### **SERVICE CHANGE 1**

# SERVICE CHANGE 2

(Fig.2) Gear Case A (Part No.416055-9)

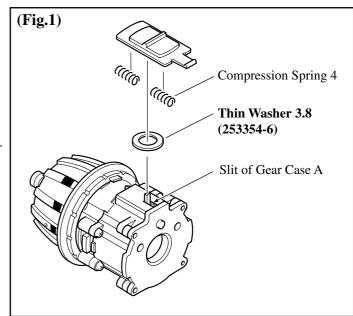
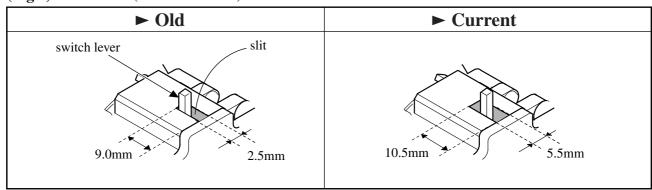
As illustrated in Fig.2, the slit of Gear Case A has been enlarged in order not to damage the switch lever since Aug., 1999. (Refer to Technical Information No.58162.)

Due to this modification, the current Gear Case A has come to require Thin Washer 3.8 in order to protect Compression Spring 4 from accidentally falling through the slit into Gear Case A.

And so, be sure to use Thin Washer 3.8 for the machine that includes the current Gear Case A.

Note: Addition of Thin Washer 3.8 is a temporary step until the slit is modified again around Feb.,2000.

Item No.	Current part	Q'ty	I/C	New part	Q'ty
28				Thin Washer 3.8 253354-6	1

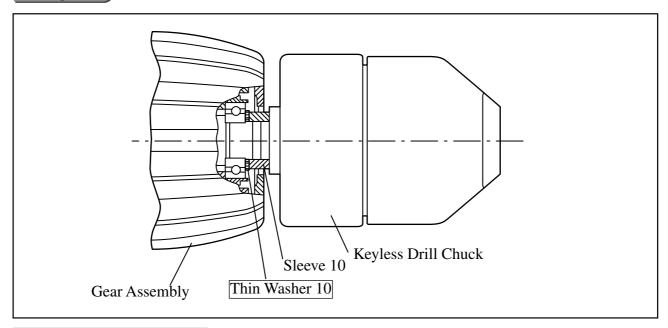
Description Thin Washer 10 has been added as illustrated below.

Fig. No.	Current part	Q'ty	I/C	New part	Q'ty
27				Thin Washer 10	1
21				253330-0	1
